STATE OF NORTH CAROLINA
DEPARTMENT OF TRANSPORTATION

Subject: **Request for Section 401 Modification** for US 1 Vass Bypass, Moore/Lee County; TIP No. R-0210WM; Federal Aid No. NHS-1 (108); State Project No. 6.569005T; Division 8; Debit \$475.00 from WBS 34330.4.3.

Attachment A - Summary of Emergency Spill Control Measures and Devices - Location and Site Identification
TIP No. R-210 WM

TYPE OF WORK: STORMWATER DEVICES

SPECIAL SWALE W/RIP RAP BERM -TYPICAL-

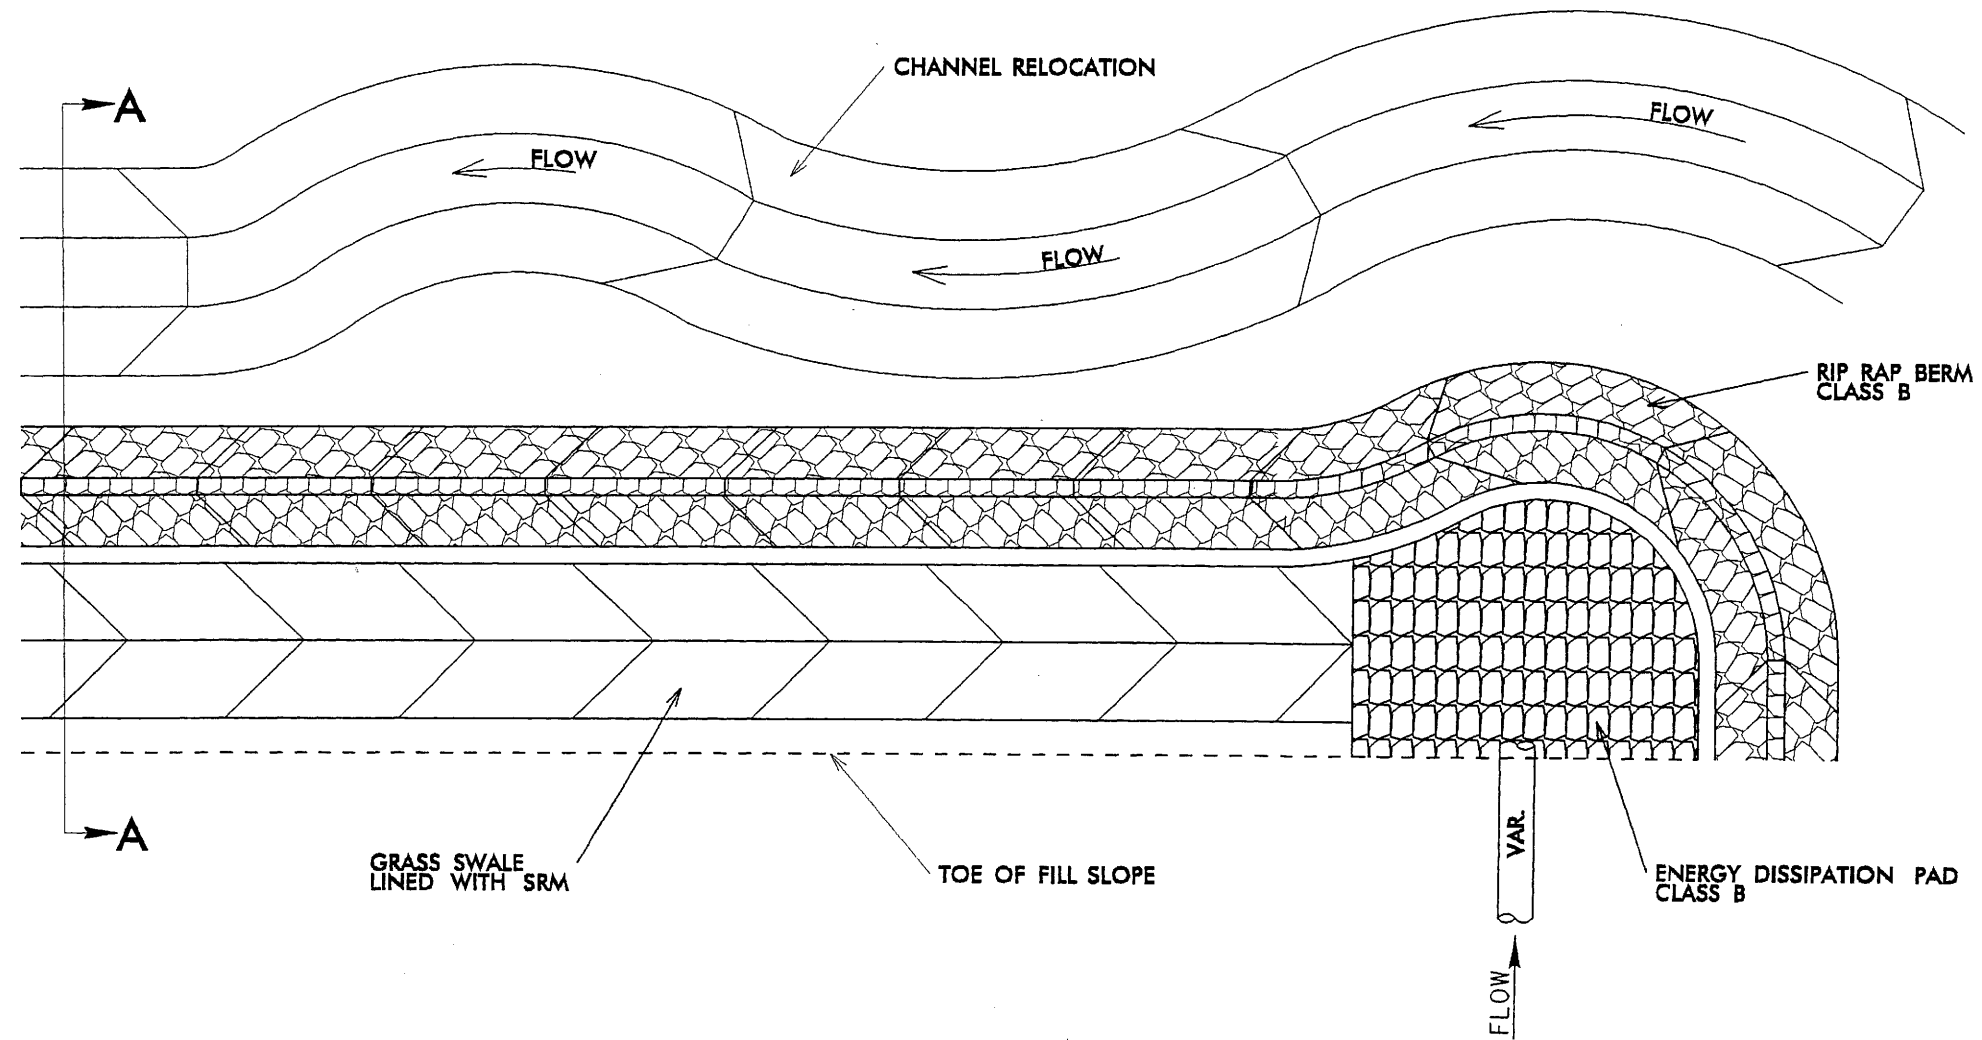
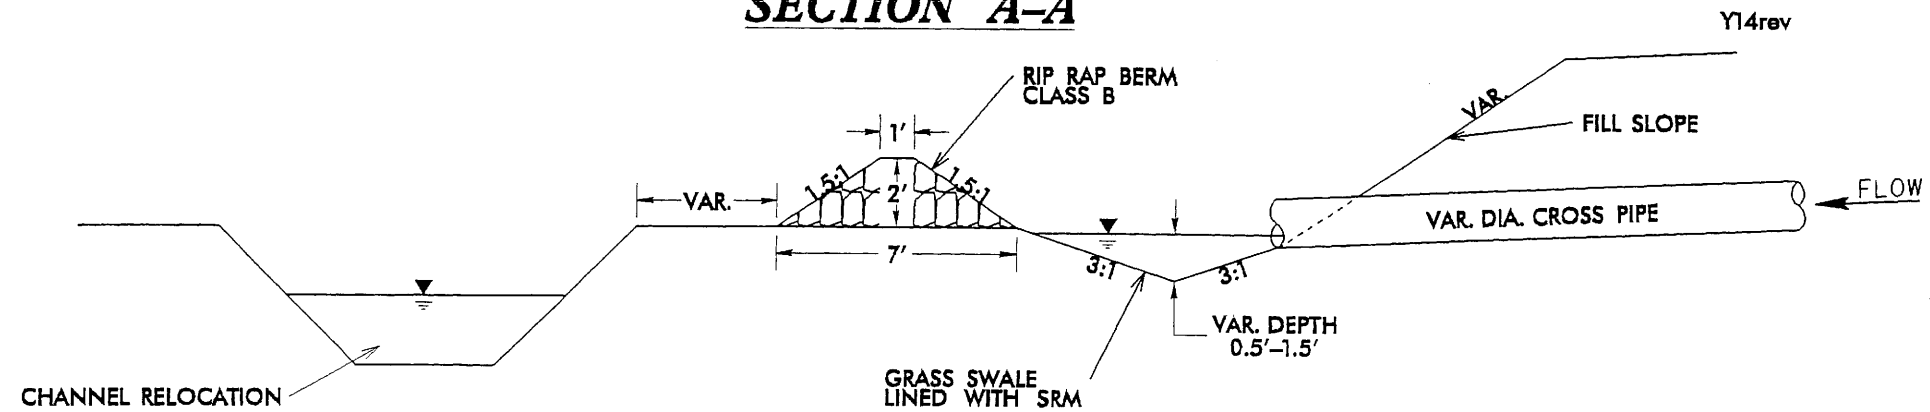
- At Station No. 29+10 Left (Site AA) and 31+10 Left (Site BB) on Sheet 22 TIP No. R-210 WM, the NCDOT will construct an energy dissipation pad at the pipe outlet which will flow into a grassed swale. Notes have been included on the plan sheet to describe this work. A typical of the swale is included in Attachment B, Sheet 2, of this letter.

-L- STA. 28+80 Lt TO STA. 29+10 Lt. R-0210 C*
-L- STA. 30+50 Lt TO 31+20 Lt R-0210 C

*NOTE: REMOVE 8'+/- OF 15" RCP AT -L- STA 29+10 Lt

METRIC	PROJECT REFERENCE NO.	SHEET NO.
	R-0210WM	13
	R-0210A	20
	ROADWAY DESIGN ENGINEER	HYDRAULICS ENGINEER
CONST. REV.		
R/W REV.

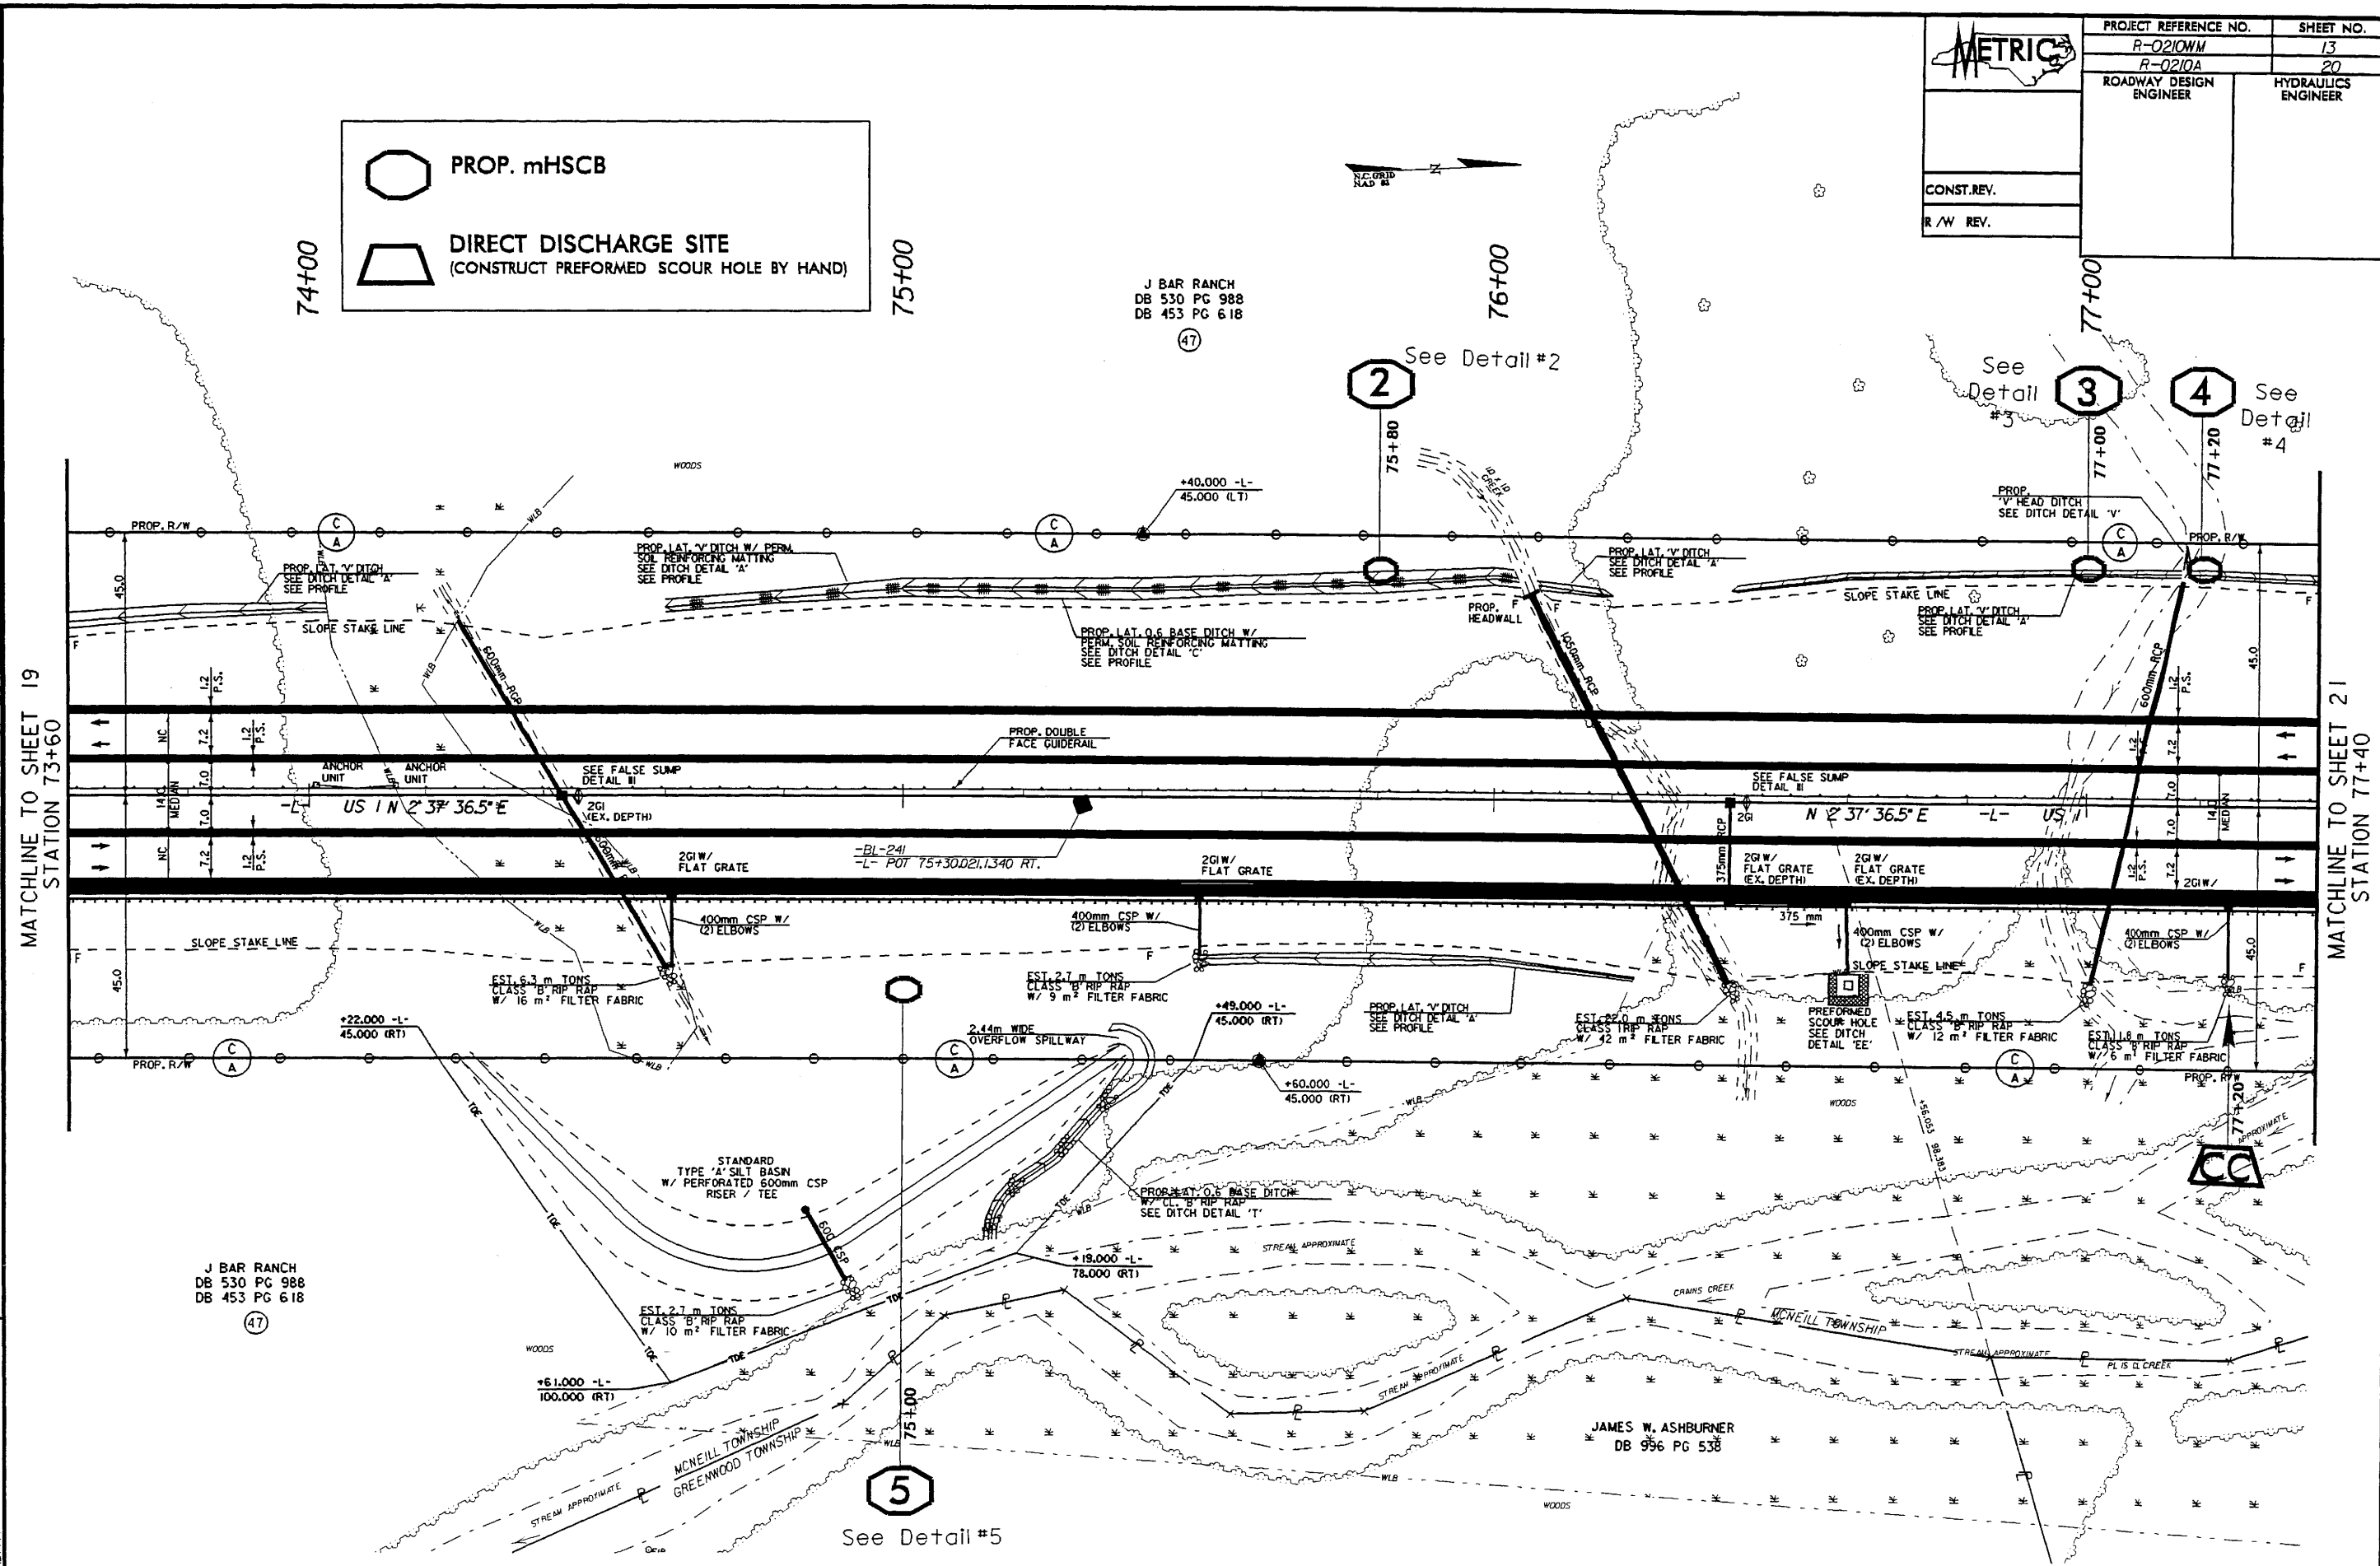
- At Station No. 77+20 Right (Site CC) on Sheet 13 of TIP No. R-210WM, the NCDOT will eliminate this direct discharge by constructing a pre-formed scour hole. There is restricted access at this location. This work will be by hand due to the high fill, guardrail and the adjacent wetlands. Notes have been included on the plan sheet to describe this work.

PROP. mHSCB
 DIRECT DISCHARGE SITE
 (CONSTRUCT PREFORMED SCOUR HOLE BY HAND)
